## **Appendix 4.1: Report for Design Changes for Line 3A Phase 1**

**HO CHI MINH CITY URBAN RAILWAY CONSTRUCTION PROJECT  
LINE 3A PHASE 1 (BEN THANH – MIEN TAY TERMINAL)**

**REPORT FOR DESIGN CHANGES**

**May 2016**

Figure 2.2.2 Plan and Profile between C8 and C9 Proposed by the JST

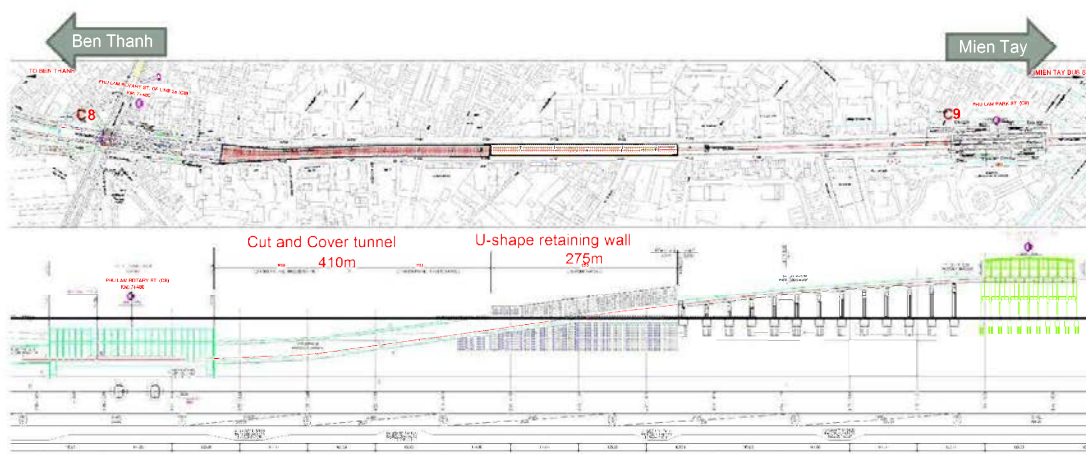
In more details, section from C8 to C9 was designed as the underground structure as shown in Figure 2.2.1, which is revised as indicated in Figure 2.2.2, namely, transition section by cut & cover tunnel and u-shape retaining wall is designed through to the elevated section between C8 and C9.

Figure 2.2.3 Comparison between FS and future Revised Design for Phase 2 from C10 to C11 Elevated Stations

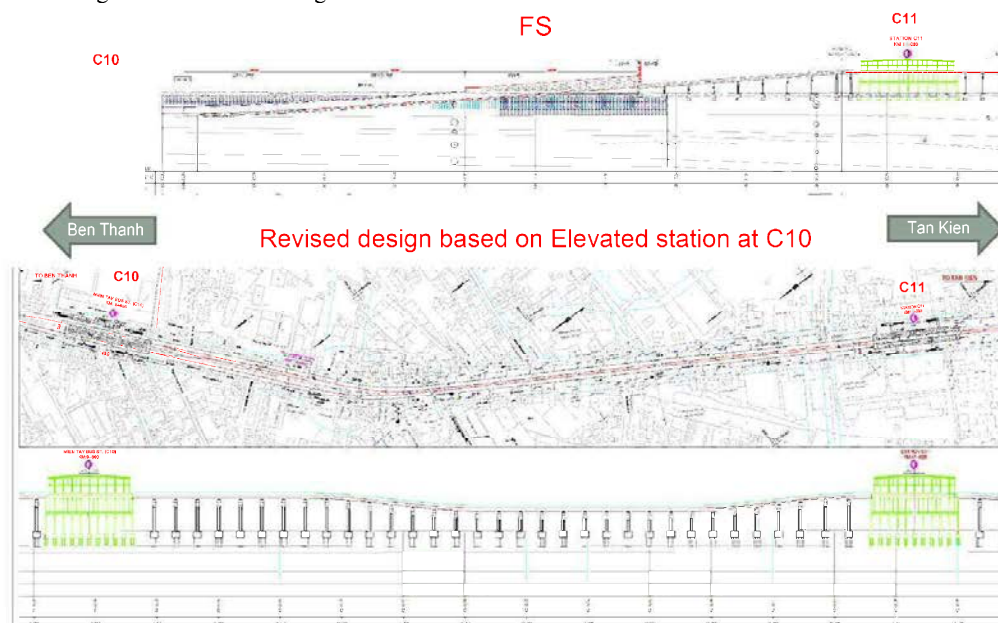
Originally, the transition section was located between C10 and Hi-Tech-Healthcare Park Station (C11) for Phase 2, and therefore from C10 to C11 will be the elevated sections as given in Figure 2.2.3 for the future design of Phase 2.

The alignment design of the viaduct is to maintain the concourse level and platform level of the station. Hence, after passing the station the railway level should be lower than that of the station to save the construction cost complying with the maximum gradient of 35/1000, which must be envisaged in the Phase 2 stage.

Figure 2.3.1 Plan and Profile at C9 Proposed by the JST

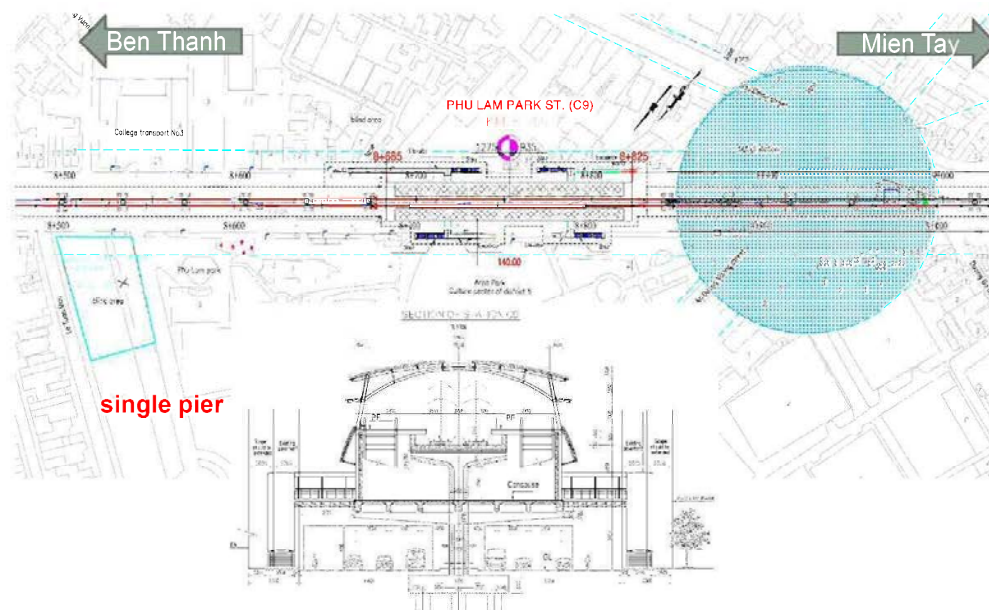
In more details, substructures of C9 are single piers as indicated in Figure 2.3.1 In the meantime, those of C10 are double piers considering deflection of super structure and stability of whole structure, since C10 has an island platform connecting with three tracks.

C9 moved 90m toward Mien Tay bus station to close to the transport hub considering accessibility of users. However, due to the development plan of the roundabout in the future, which is highlighted in blue, all station facilities are kept outside of the development plan.

Figure 2.3.2 Plan and Profile at C10 Proposed by the JST

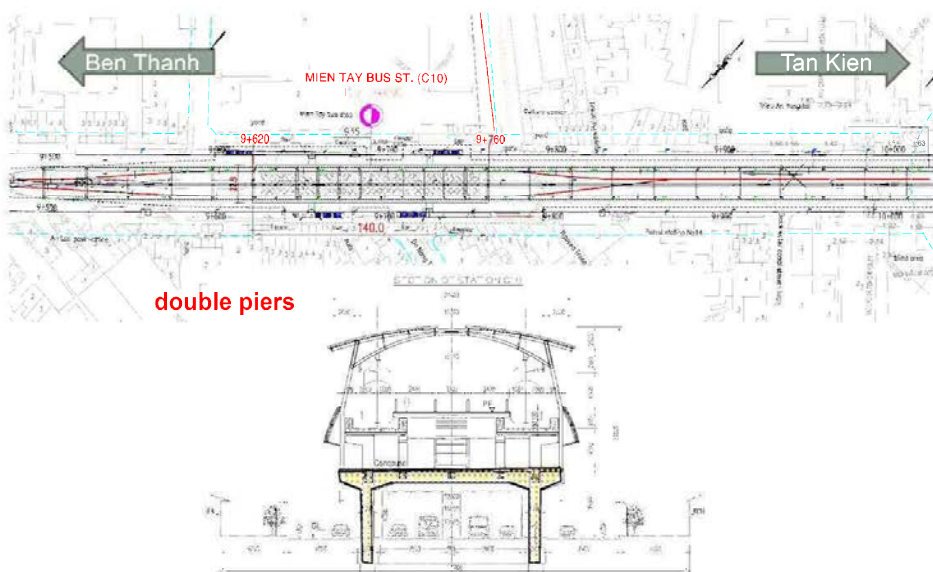
As shown in Figure 2.3.2 C10 is revised from underground to elevated station. Also, the centre of the station is revised from Km 9+700 to Km 9+ 690 due to the alignment change.

Figure 2.4.1 Plan of Relocation of Power Cables

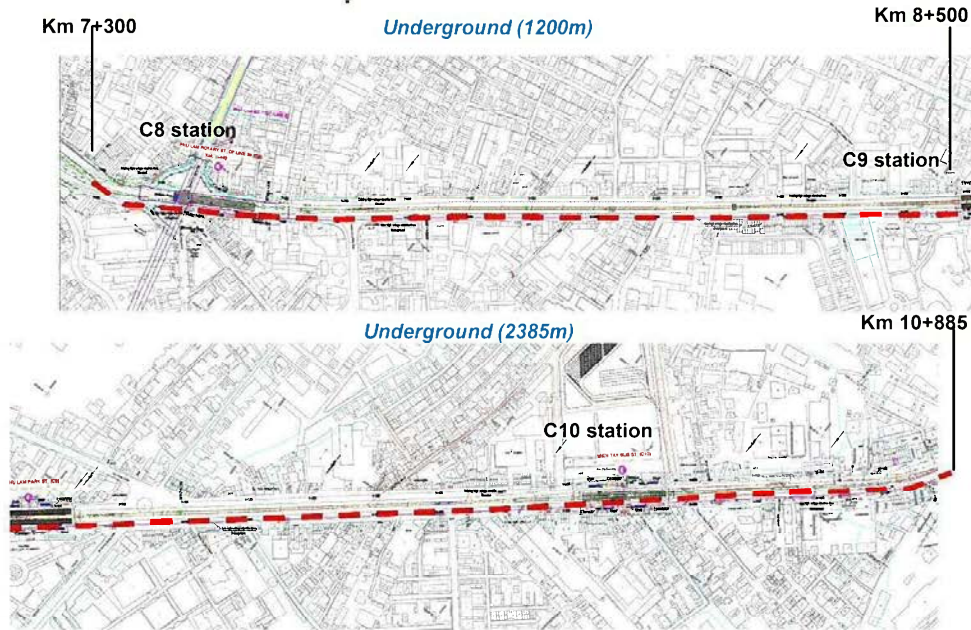
In order to build the elevated section, power cables needs to be relocated for about 3.6km as shown in Figure 2.4.1. According to the meeting with EVN held on 21 April 2016 where JST exhibited underground and elevated options, EVN preferred underground option based on their experiences considering safety, maintenance and adjacent impact.

Figure 2.4.2 Section of Relocation of Power Cables

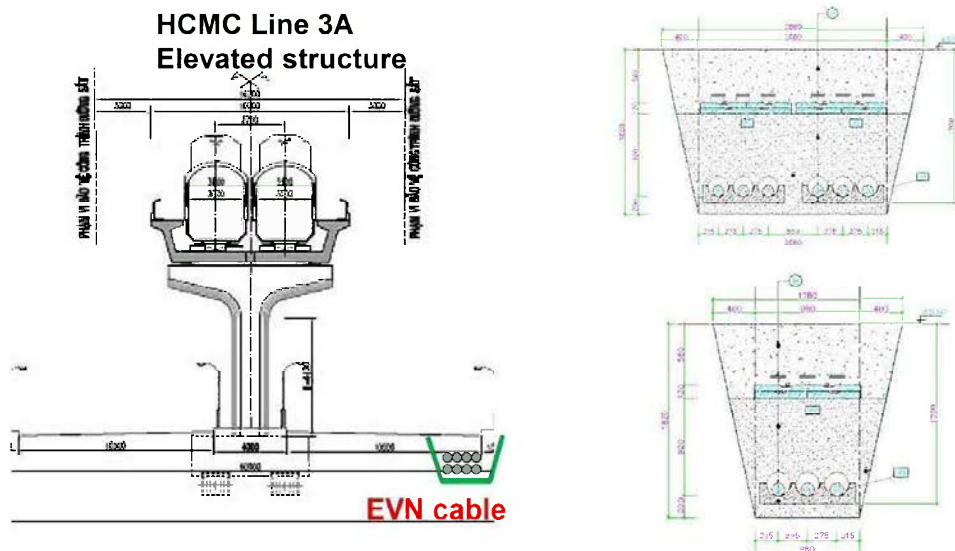
The meeting concluded that power cables will be relocated to underground using HDPE pipes and protected by concrete slab referring to other projects carried out by EVN as indicated in Figure 2.4.2.

Theo JST, Công ty lưới điện cao thế Thành phố đã chấp thuận phương án di dời theo hướng ngầm hóa bên trong các ống HDPE và được bảo vệ bằng các tấm bê tông bên trên tại cuộc họp ngày 21 tháng 04 năm 2016. Theo quan điểm của chúng tôi, tốt hơn nên có được thỏa thuận bằng văn bản từ Công ty lưới điện cao thế Thành phố hoặc Tổng Công ty Điện lực Thành phố Hồ Chí Minh.

Figure 3.1.1 Comparison of Tunnel Construction Methods

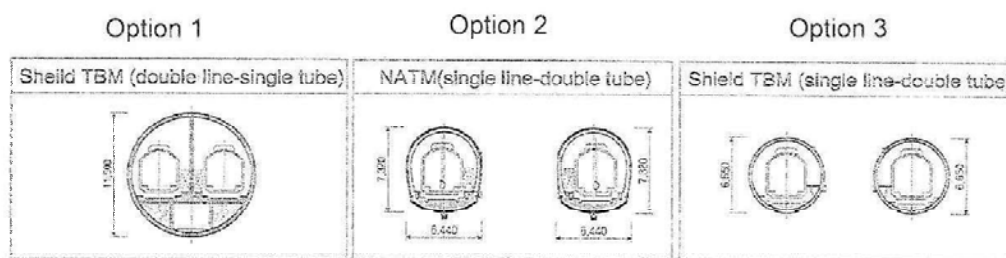
As shown in Figure 3.1.1 and Table 3.1.1, three options are compared, i.e. Option 1: Double lines of single tube by Shield Tunnel Boring Machine (TBM), Option 2: Single line of double tubes by New Austrian Tunnelling method (NATM) and Option 3: Single line of double tubes by Shield TBM.

The results show that option 3 is the most suitable method considering cost, construction schedule and neighbourhood impact. From this evaluation, the JST selected Option 3.

Figure 3.2.1 Comparison of Superstructures

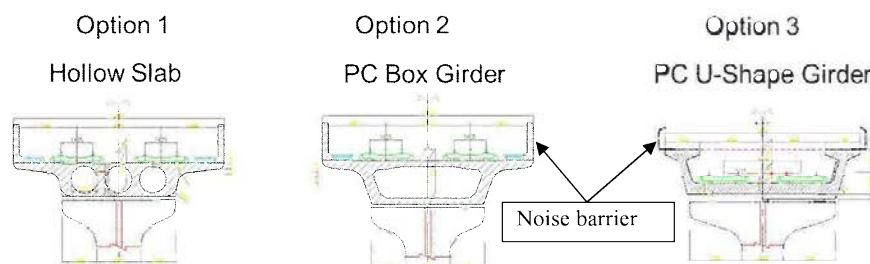
As given in Figure 3.2.1 and Table 3.2.1, three options are compared for superstructure of elevated section, i.e. Option 1: Hollow slab, Option 2: PC box girder and Option 3: PC U-shape girder.

Option 3 is concluded the most appropriate superstructure since it requires the lowest height of noise barrier and rail that may lead to the cheapest construction and maintenance costs for the elevated section. HCM Line 1 also adopted option 3 for the same reasons.

**Figure 3.3.1 Comparison of Ground Cover between FS and this Study from C1 to C2**

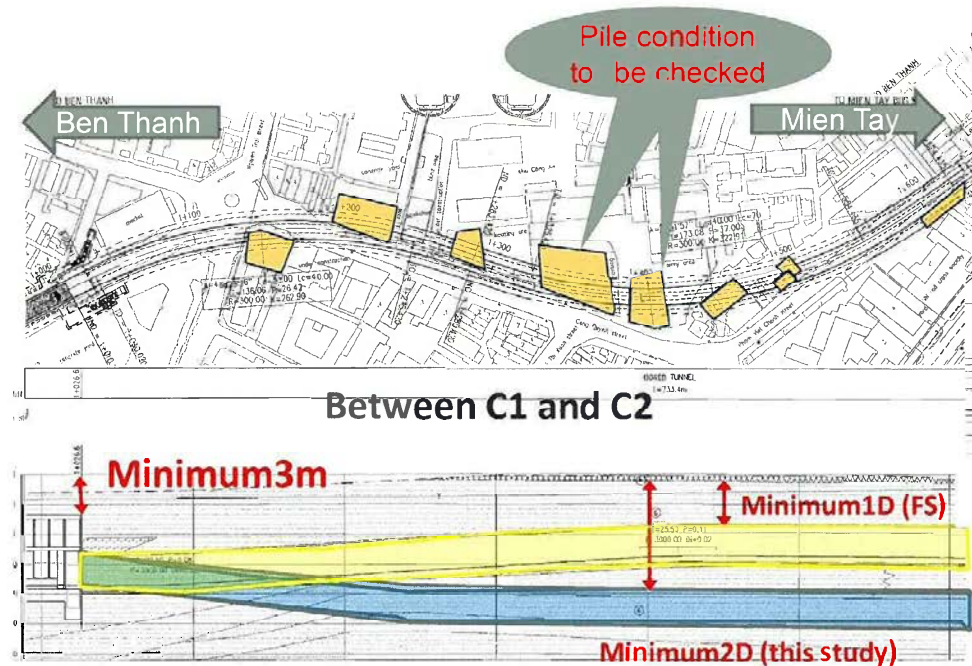
The FS designed minimum ground cover between C1 and C2 as 1D (1x6.65m). In the meantime the JST propose 2D (2 x 6.65 = 13.3m) as shown in Figure 3.3.1 considering several factors such as settlement, possibility to hit obstructs and noise & vibration as described in 3.4 and 3.5.

JST đề xuất lớp đất phủ ít nhất là 2D cho đoạn giữa ga C1 và ga C2 để giảm thiểu lún (độ lún tối đa theo tính toán là 8,8mm) và để giảm tiếng ồn và độ rung trong giai đoạn thi công và vận hành. JST nên lưu ý kết hợp với kết quả khảo sát địa chất, địa hình để chuẩn bị phương án trong trường hợp độ lún cho phép vượt ra khỏi tính toán của JST. Ngoài ra, chi phí quan trắc lún cũng cần được ước tính.

Figure 3.4.2 Comparison of Ground Cover between FS and this Study from C1 to C2

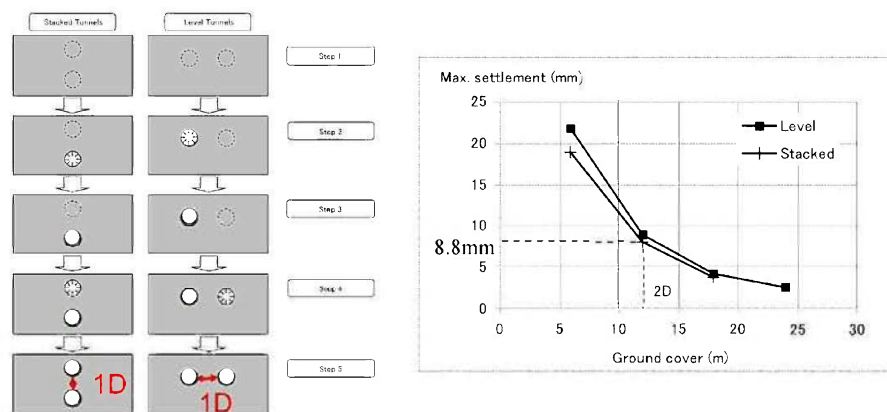
In Hanoi Line 2, the settlement calculation was carried out using different ground cover from 1D to 4D for staked and level tunnels as summarised in Table 3.4.1 and Figure 3.4.1.

The result made clear that amount of settlement values shows significant reduction over 2D of ground cover. This implies that at least 2D ground cover should be kept in terms of minimising the settlement.

Figure 4.2.1 E & M area proposed by the JST in this Study

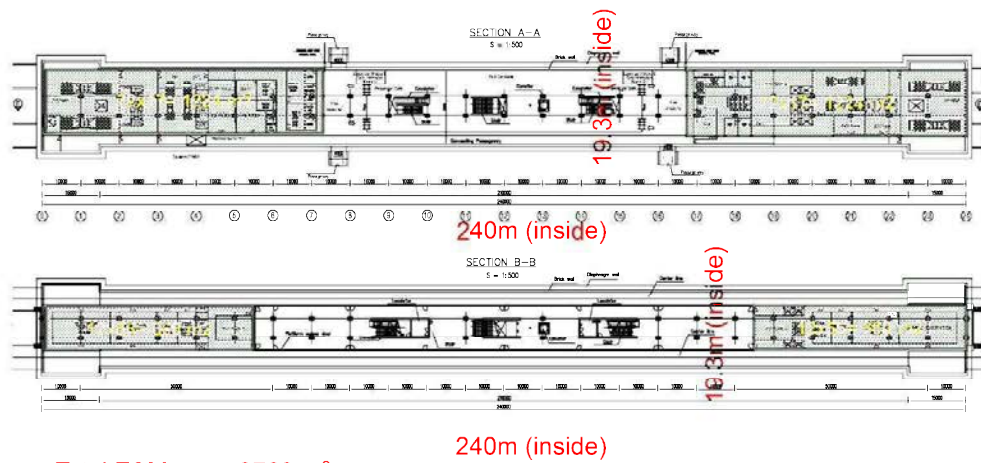
As shown in Figure 4.1.1, the FS design shows a basic station layout of 160m inside length and 17.3m inside width. This is extremely tight to accommodate both passengers and equipment. Typical metro stations have 200 to 240m in length with a similar train configuration.

Total E&M area according to the station layout of the FS design is only 1048m<sup>2</sup>, which is significantly insufficient to accommodate necessary facilities for underground stations, such as Tunnel Ventilation and Environmental Control System.

The JST revised E&M area by increasing station length and width as shown in Figure 4.2.1. Inner length increased from 160m to 240m and inner width increased from 17.3m to 19.3m. Resultantly 3768m<sup>2</sup> of total E&M area is proposed.

Figure 4.2.2 E & M area at Ba Son Station

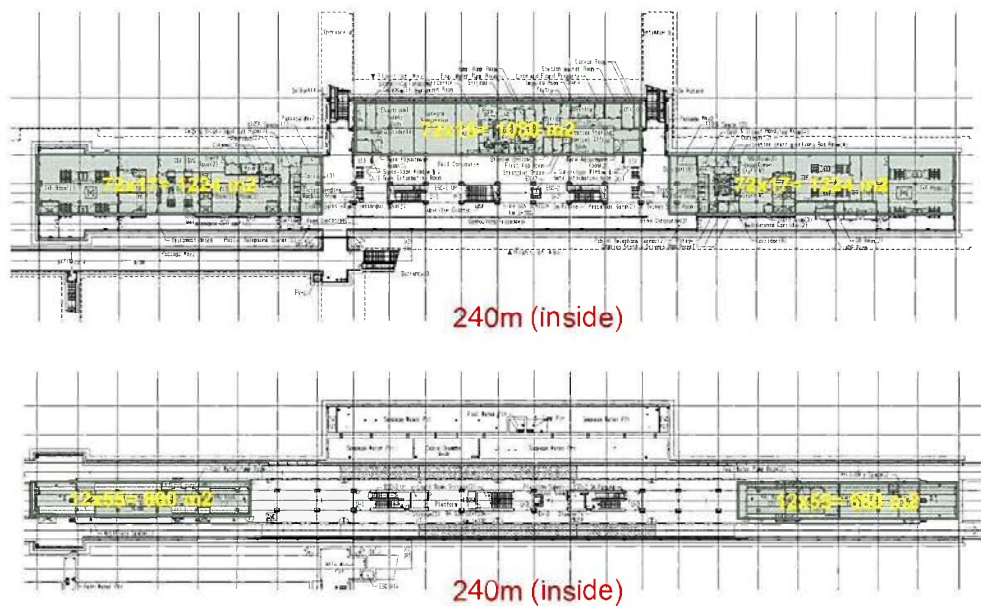
The above rearrangement is made based on the station layout and M&E locations of Ba Son station, Line 1, as indicated in Figure 4.2.2. The Figure shows that Ba Son station has a projection area for E&M works. This is because major land acquisition is allowed at the Ba Son station area. In the meantime, all underground stations of Line 3A, which are running under public roads, require best efforts to minimise land acquisition.

The JST successfully reallocated all facilities and equipment from the projection area to other rooms at concourse and platform level. As a result, total space for M&E reduced the area by about 1000m<sup>2</sup> compared with that of Ba Son station.

Figure 4.4.2 Arrangement of Diaphragm Wall in This Study

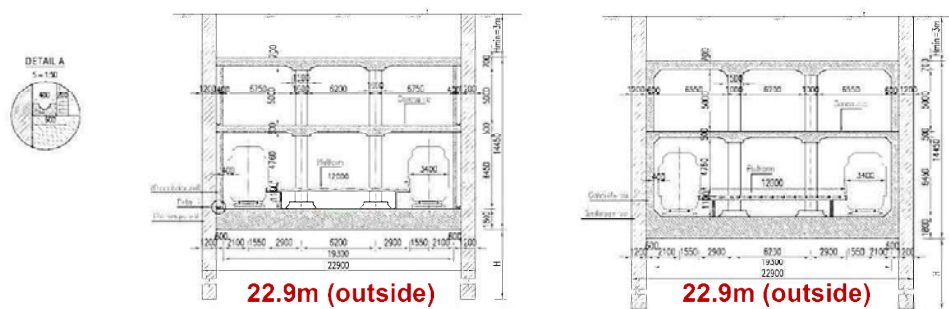
However, our experiences reveal that the above arrangement is unlikely to effectively stop water leakage even though the Contractor is obliged to maintain water leakage to acceptance level as per the project specification. In the event of water leakage at stations, public appearance will be negative.

The JST propose Option 1: DW with drainage and brick wall and Option 2: DW with in situ concrete as illustrated in Figure 4.4.2. The advantage of Option 1 is an ability to drain water leakage (within acceptable range by the project specification) through drainage with brick coverage wall in order to maintain a good public appearance. In addition, the brick wall, having openings with a proper interval, will ease maintenance. In spite of the above advantages, the FS and HCM Line 1 selected Option 2.

For the DW thickness, the JST propose 1.2m instead of 1.0m (as in the FS) considering structure stability and reducing settlement and adjacent impact.

Having compared with five items among FS, Option1 and Option 2 as summarised in Table 4.4.1, the JST recommend Option 1 as the most suitable method. The method was, in fact, applied in Delhi Metro and Singapore Metro.

Figure 5.1.1 C1 Location between FS and this Study

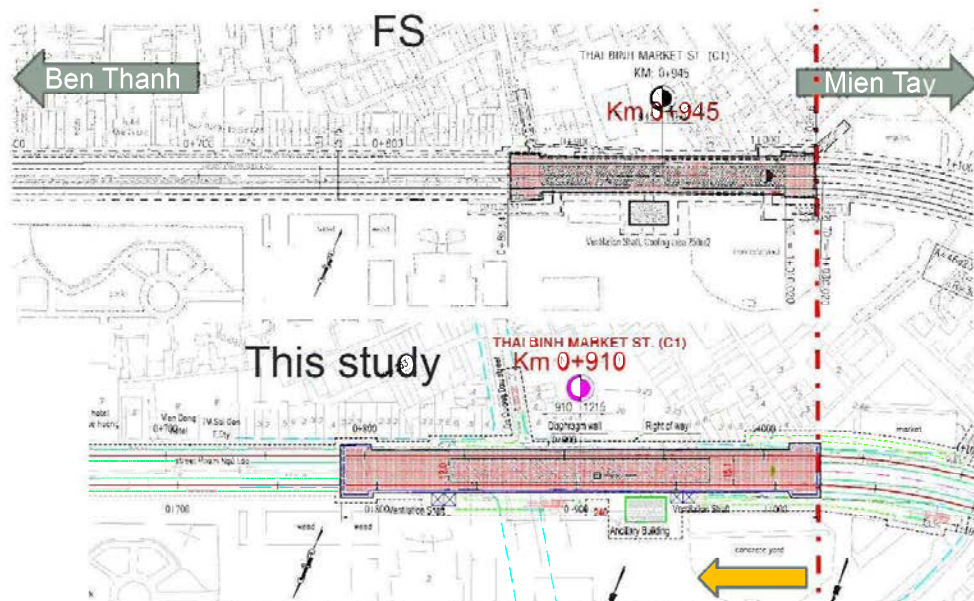
Station length is, in general, expanded from the centre of the station associated with the change from 160m to 240m. Exceptionally in the case of C1, the station length is extended in one direction due to a curvature to Ben Thanh direction. Hence, the centre of the station is revised from Km 0+945 to Km 0+910m as shown in Figure 5.1.1.

Figure 5.2.1 C2 Location between FS and this Study

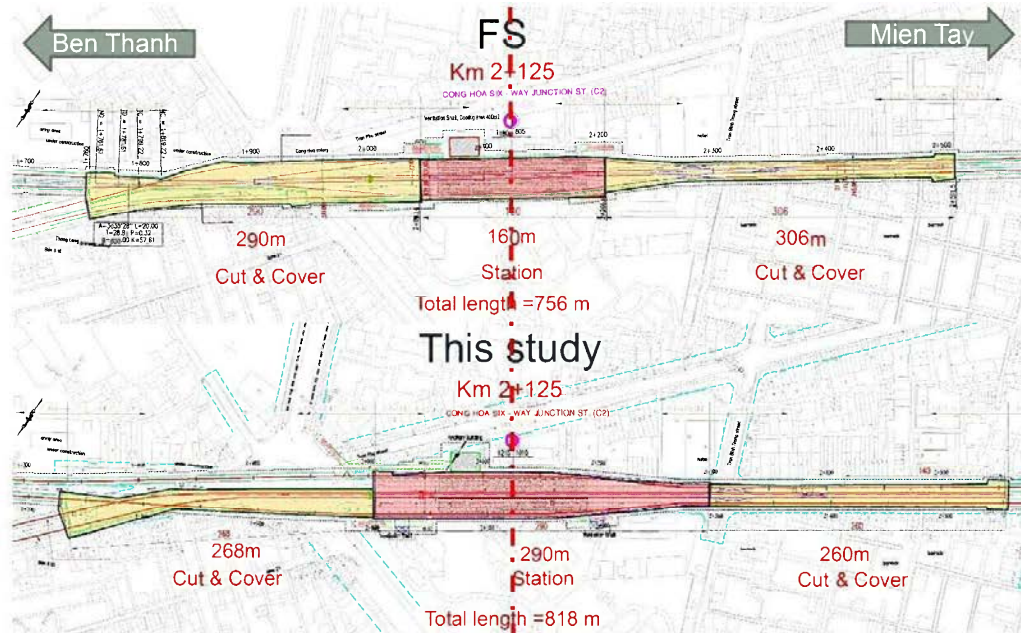
The centre of the station remains unchanged, while the station and cut & cover lengths for crossing trains are revised as indicated in Figure 5.2.1.

Figure 5.2.2 Track Layout at C2 between FS and this Study

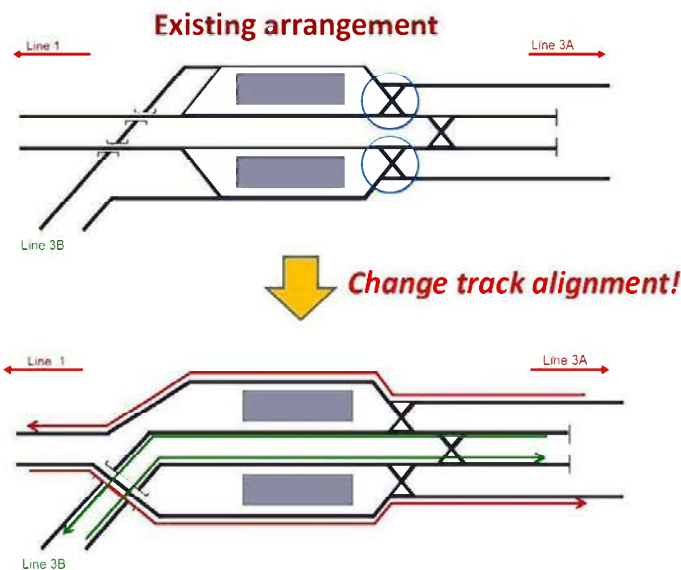
This is because of the change in train operation and track layout of C2 as shown in Figure 5.2.2.

With regard to the track layout (see Figure 5.2.2), Line 1 and Line 3B tracks are moved outside and inside respectively to maintain connectivity with Line 3A and eventually achieve more punctual operation. With this arrangement, trains which run through from Line 1 to Line 3A and trains of Line 3B which return at C2 will not disrupt each other at turnouts on the Mien Tay side. This will help reduce the delay at the intersection.

Hence, the JST propose that all trains of Line 3B will return at C2. This means Line 3B system is operationally separated from Line 1 and Line 3A systems till operation personnel equip sufficient skills and experiences.

Figure 5.3.2 C3 Location between the JST and Saigon Star Proposals

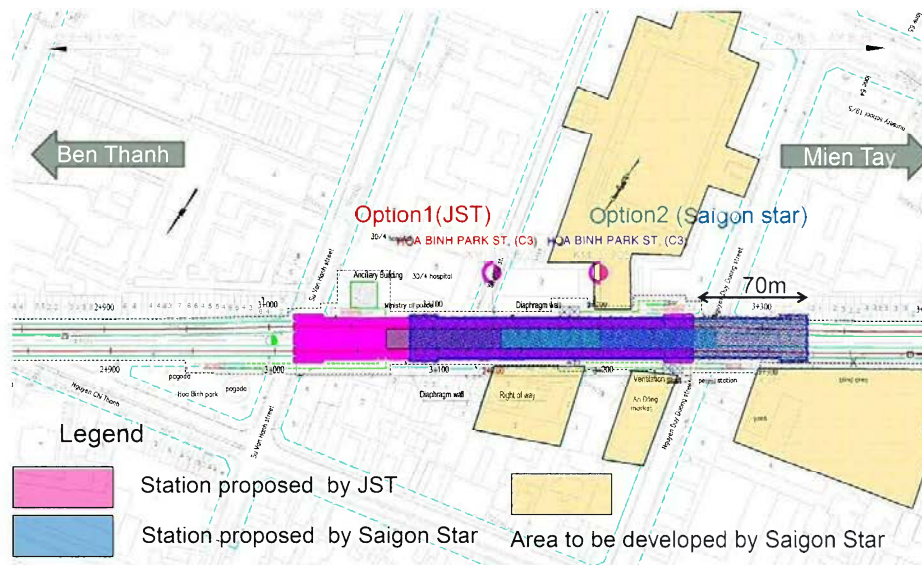
C3 was originally located at Km 2+930 as indicated in Figure 5.3.1, while Saigon Star requested alternative location (the centre of station is at Km3+205 (Option 2)) adjacent to their properties to be developed in the future, which is highlighted in yellow.

After careful review of their proposal, the JST identified even better location, which is at Km 3+135 (Option 1) with full consideration of accessibility from the neighbourhood and land acquisition as illustrated in Figure 5.3.2.

In conclusion, the JST recommend Option 1 for three reasons in Table 5.3.2. As the difference between Option 1 and 2 is only 70m, accessibility from their properties has almost no change, while land acquisition area has great difference.

Việc yêu cầu xem xét vị trí của ga C3 là theo đề nghị của Ủy ban nhân dân Quận 5 kèm đề xuất của Công ty Sài Gòn Star. Do đó, việc báo cáo đề cập “Công ty Sài Gòn Star mong muốn thay đổi vị trí ga sao cho tiếp giáp với các công trình được quy hoạch phát triển trong tương lai” có thể gây hiểu lầm. Đề nghị JST hiệu chỉnh nội dung này cho phù hợp.

Therefore, the content which the report mentioned that “Saigon Star requested alternative location adjacent to their properties to be developed in the future” may lead to misunderstanding. We propose JST to revise for its appropriateness.
